San Onofre Nuclear Generating Station
Unit 1

RESPONSES TO NRC REQUEST FOR
INFORMATION, TURBINE BUILDING RESPONSE SPECTRA

Impell Report No. 01-0310-1451
Revision 0

July, 1985

FIGURE 2.1

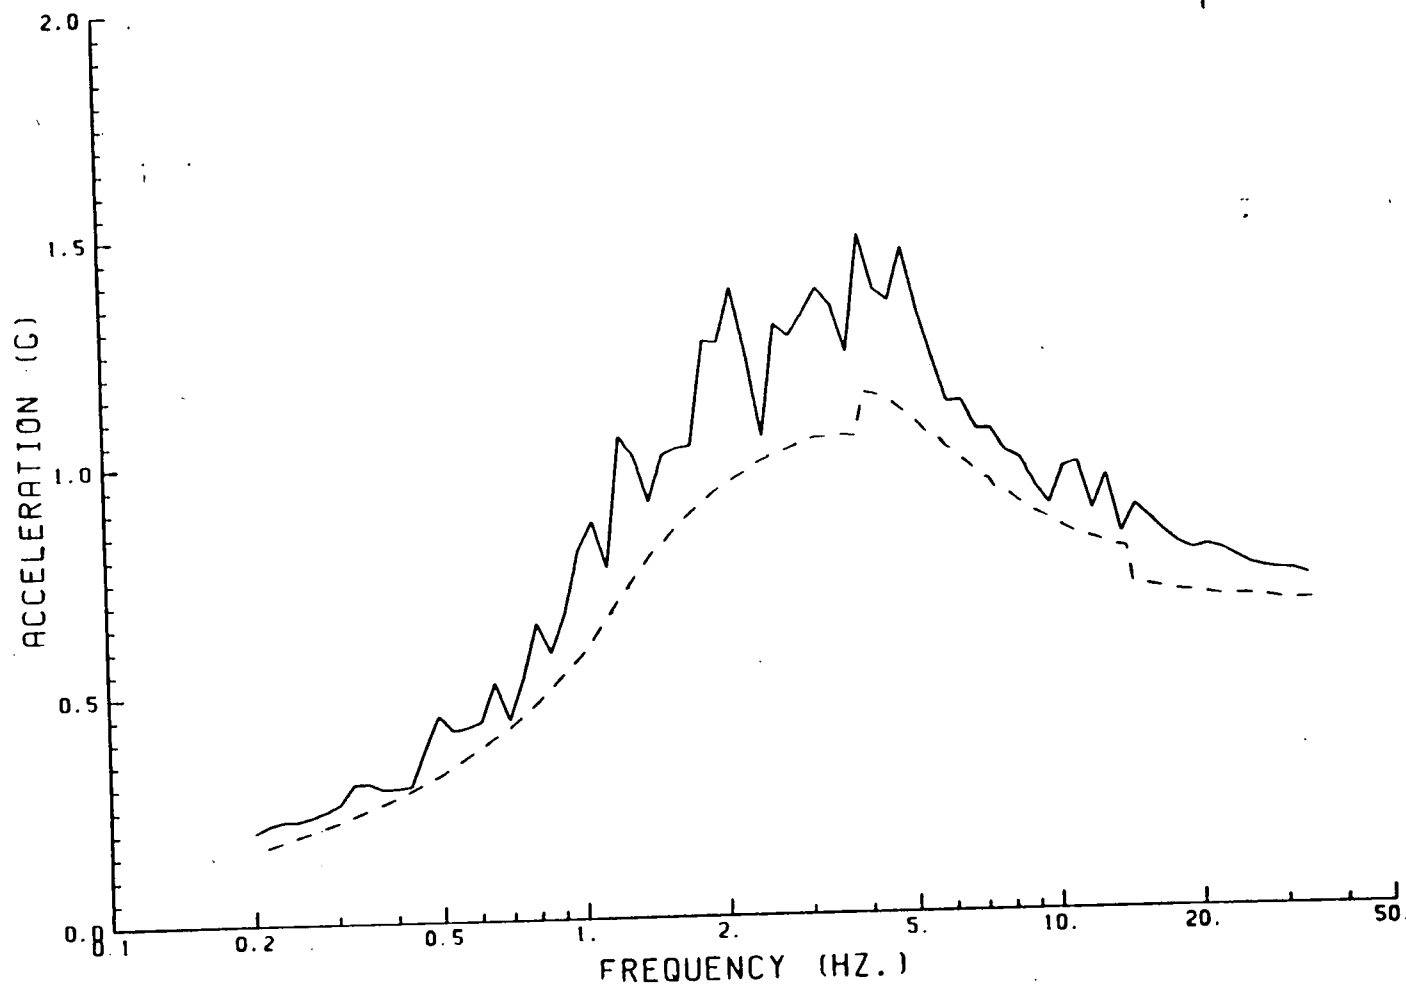
Use FLORA narrow-band methodology to calculate correction factors at two spectral points at two independent Turbine Building nodes and compare with analysis values.

The model used for the analysis is shown in Figure 2.1. This is a fixed-base model provided by the NRC for FLORA verification purposes (NRC-test problem III, Reference 1). The modal properties (frequencies, mode shapes) generated for the test problem were used for the computation of the correction factors.

Spectral values were computed at two nodes (node 4 and 11) in the model and at a total of 26 frequencies, including the fundamental structural frequency (5.26 Hz). Consistent with the application used for the Turbine Building, the mass of the secondary system is zero ($EM=0$), i.e., primary-secondary system interaction is not considered.

Table 2.1 shows that the method used to calculate the correction factors implemented in the Turbine Building spectra are similar to those calculated with FLORA using either the wide- or the narrow-band options. In Table 2.1, a positive percentage difference indicates that the values calculated by FACTOR are conservative, i.e., less reduction is applied to the time history's spectra. As shown in the Table 2.1, the largest differences between FACTOR and FLORA are positive, thus conservative.

The methodology used for the development of correction factors applied for the Turbine Building response spectra is correct and conservative.

TABLE 3.1

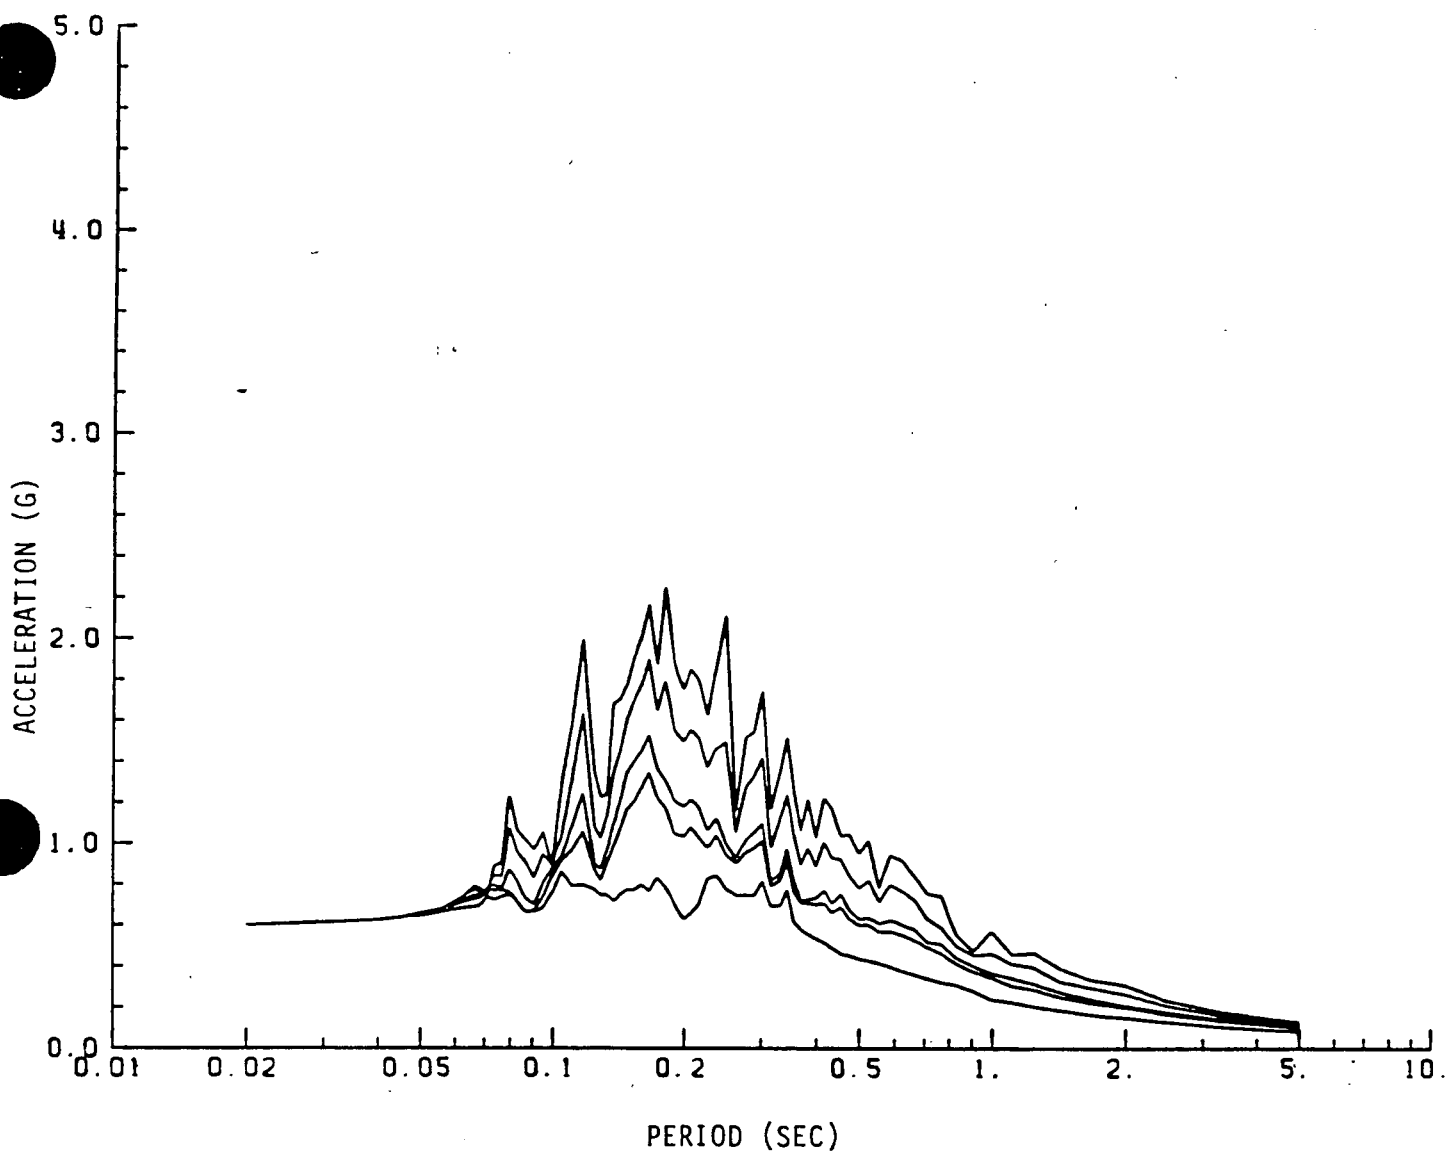
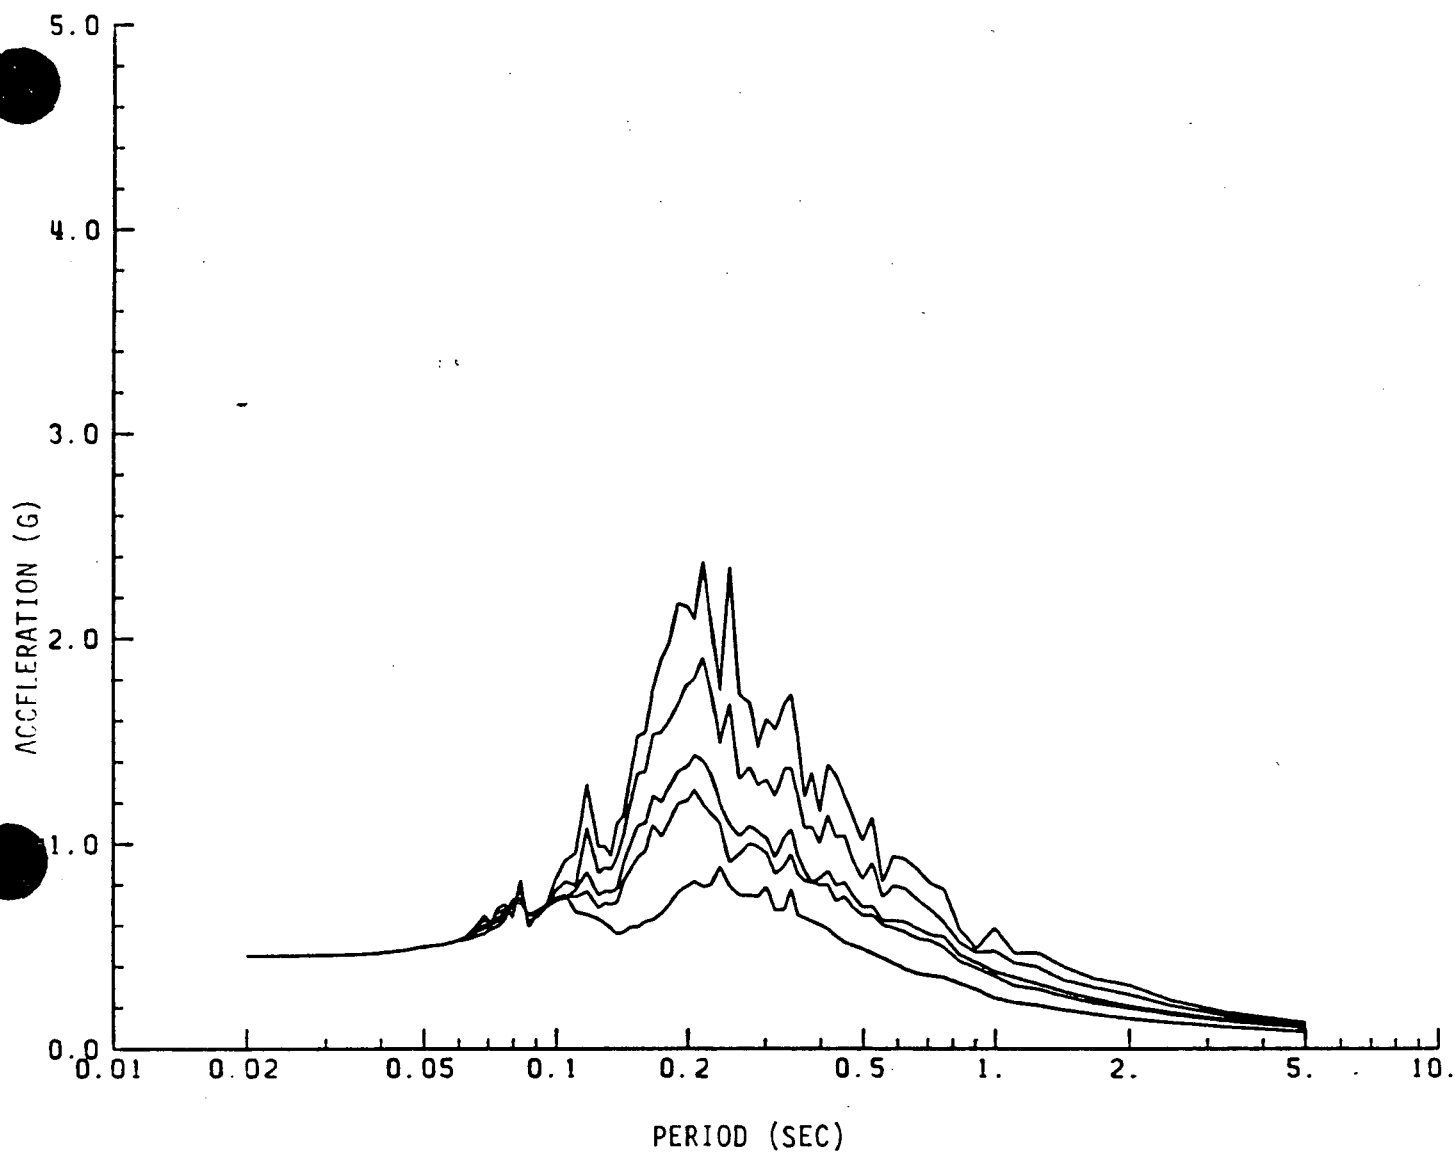
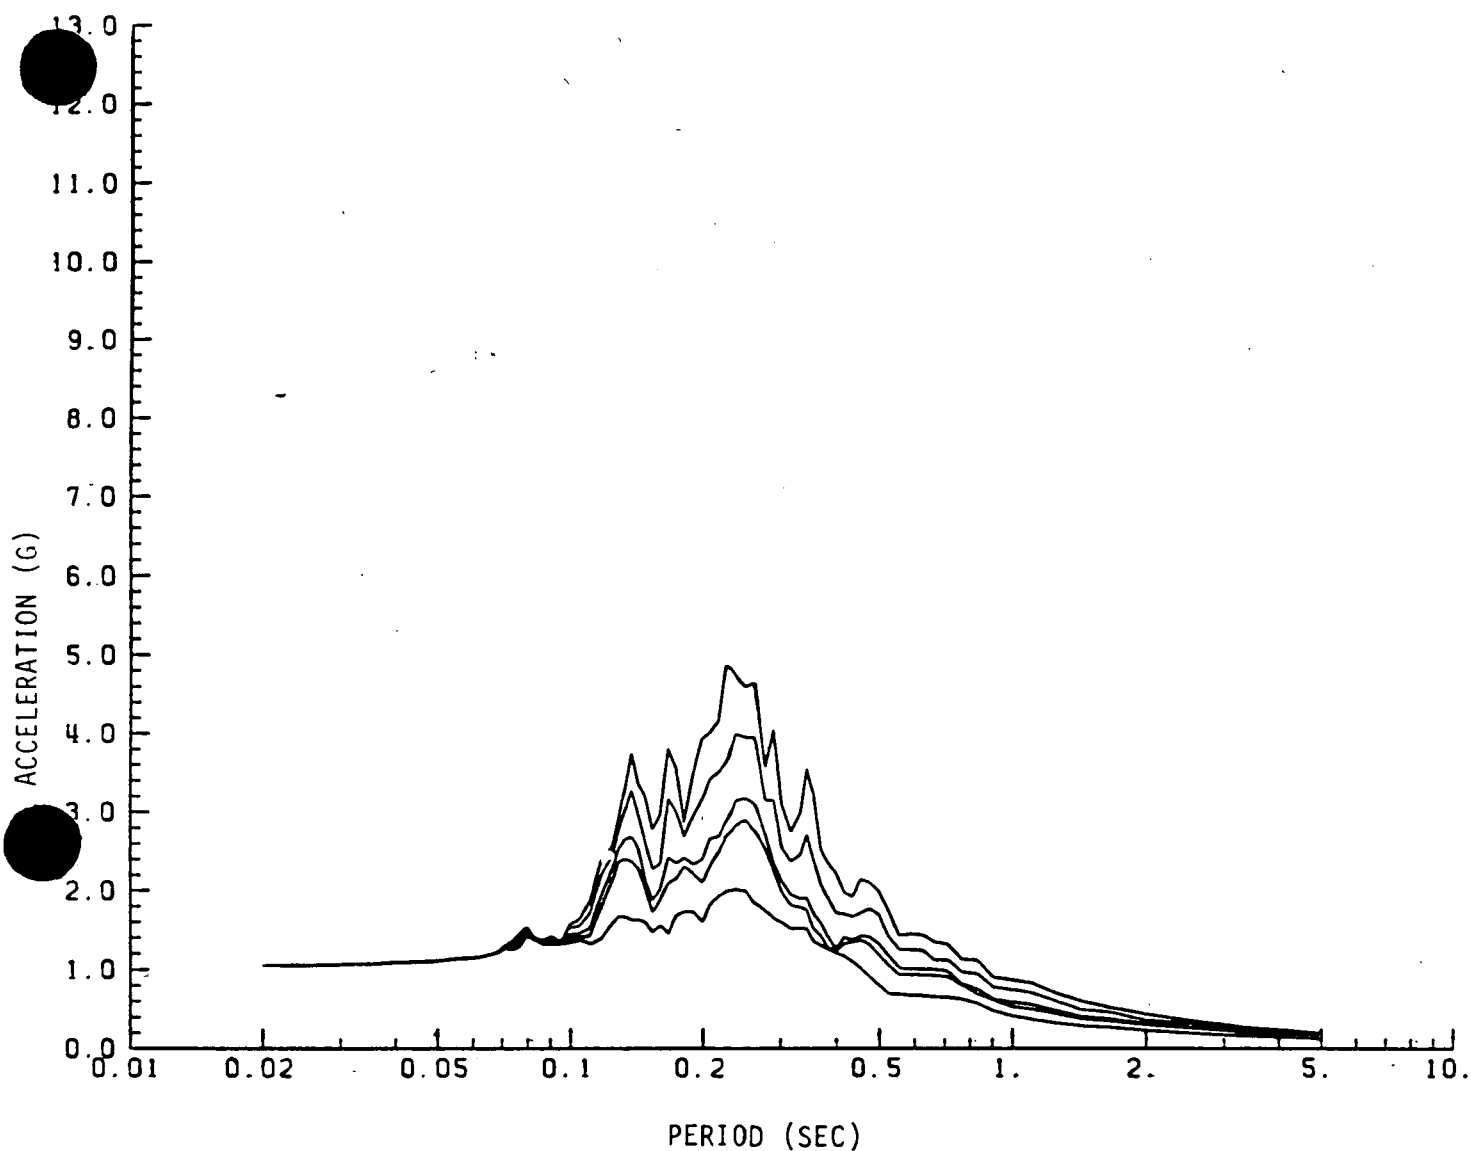
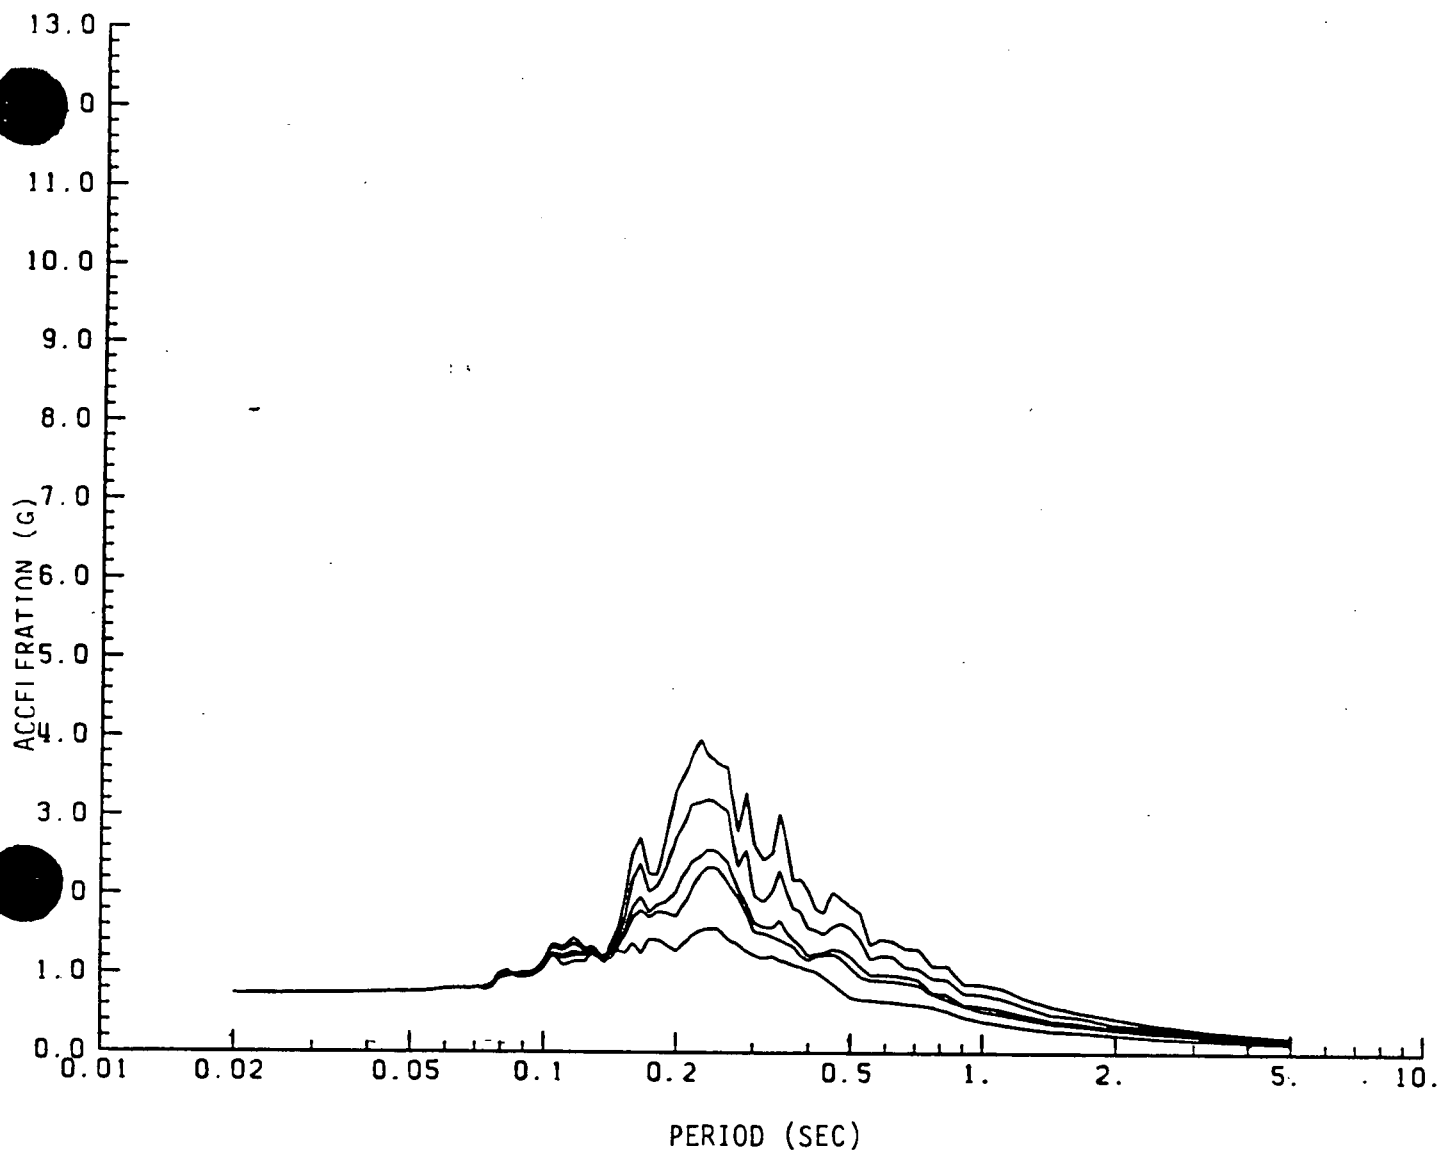
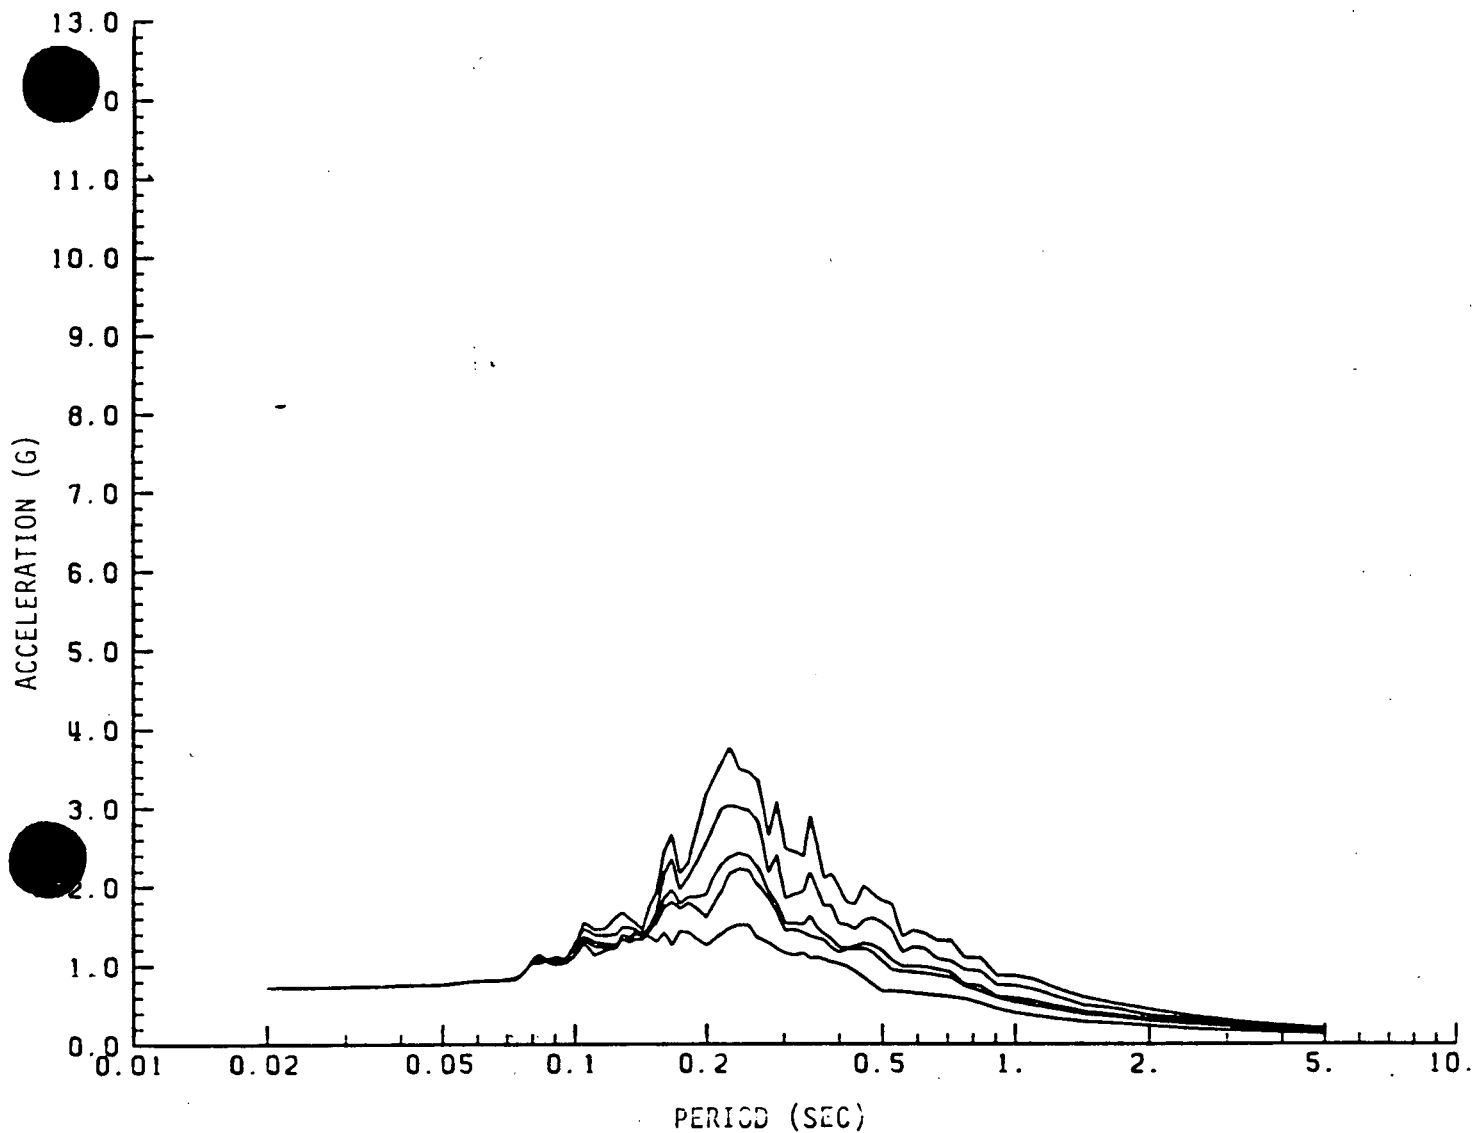
Provide comparison of Turbine Building floor response spectra with previous Bechtel spectra at two locations.

Raw response spectra, for 2% damping, generated by Impell and those generated by Bechtel are provided for the following locations:

- 1) Nodes 580, 586 and 610 in Area 2, North Extension, Elev. 42.0' for North-South Direction.
- 2) Nodes 29, 71 and 86 in Area 6, West Heater Platform, Elev. 35.0' for East-West and Vertical directions.
